Reviewed for code compliance
with IRC 2015
Kitsap County Building Department
jbowling@co.kitsap.wa.us
08/04/2020

FOUNDATION PLAN	WNEK BARN	WASHINGTON	BREMERTON	Prepared for:	MIKE AND CAROL WNEK 1655 SHERWOOD DRIVE BREMERTON, WA 98311
				Revisions:	
S1				SCALE: 1/4" = 1'-0" (24x36)	DATE: 07-22-20
				DESIGN BY: EPA	DRAWN BY: CDH
				PROJ. #:	...
				Prepared By:	AUSTIN ENGINEERING CIVIL ENGINEER
					2182 NE ETON LANE BREMERTON, WA 98311 (360) 698-1661

DETAILS
WNEK BARN

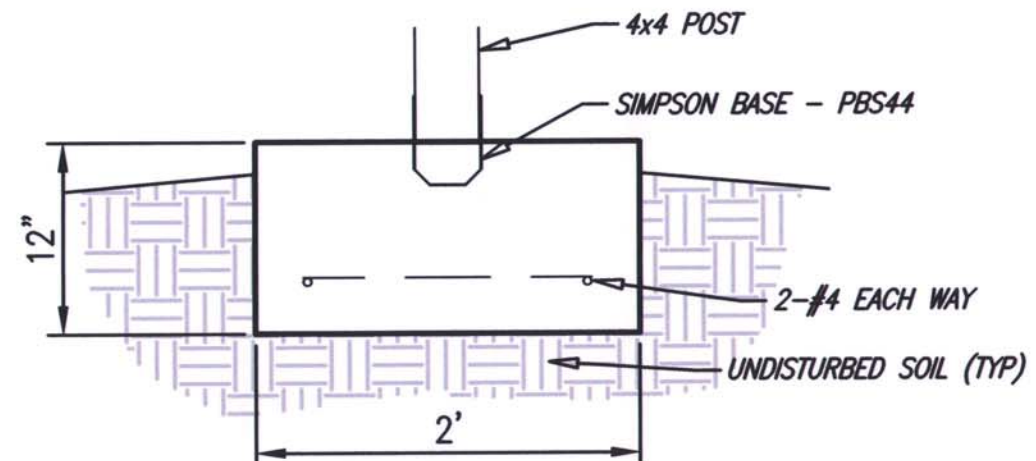
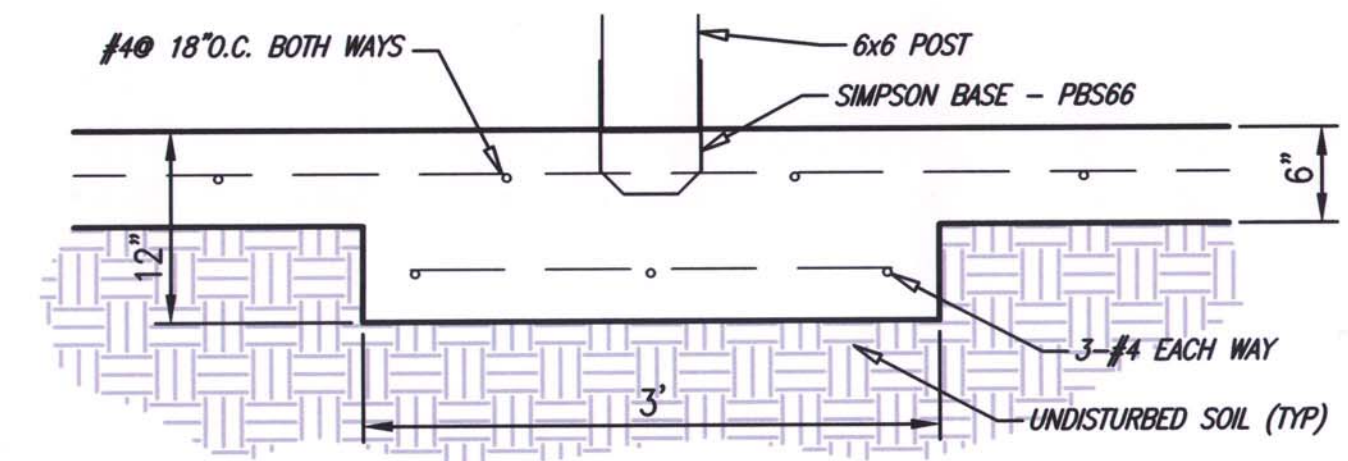
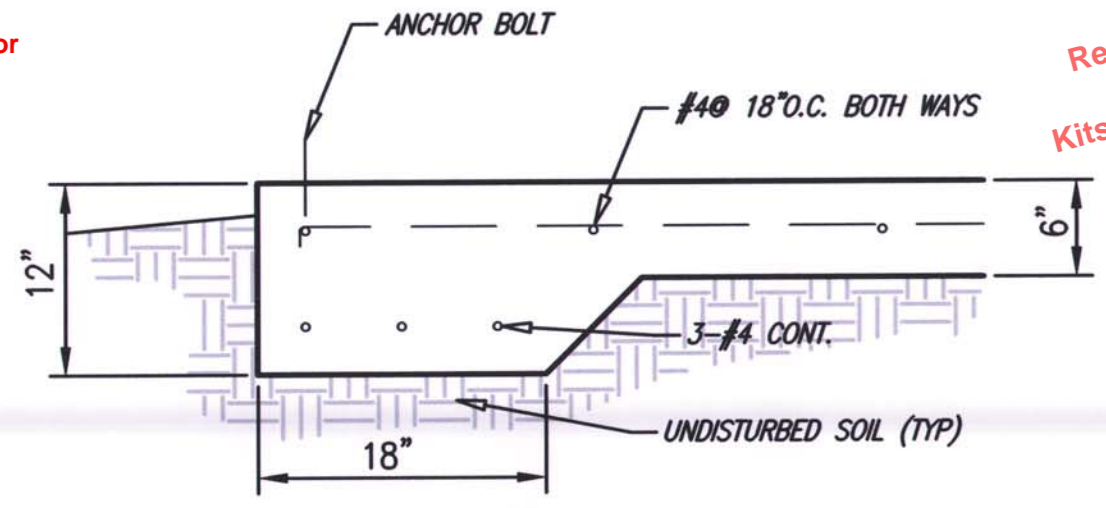
5/8" Type X, fastened
6" on center at bottom
of floor joist.

Construction Details

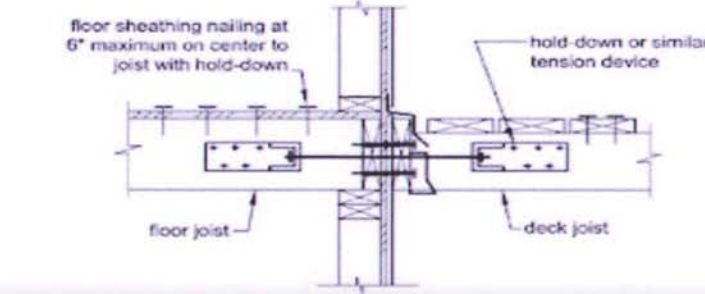
2" x 10" Joist
16" O.C. Joist spacing
4" x 10" Support Beam(s)
4" x 4" Support Post(s)
7" Post Spacing
Footing Size:
Round: N/A
Square: 2' x 2' by 12" deep
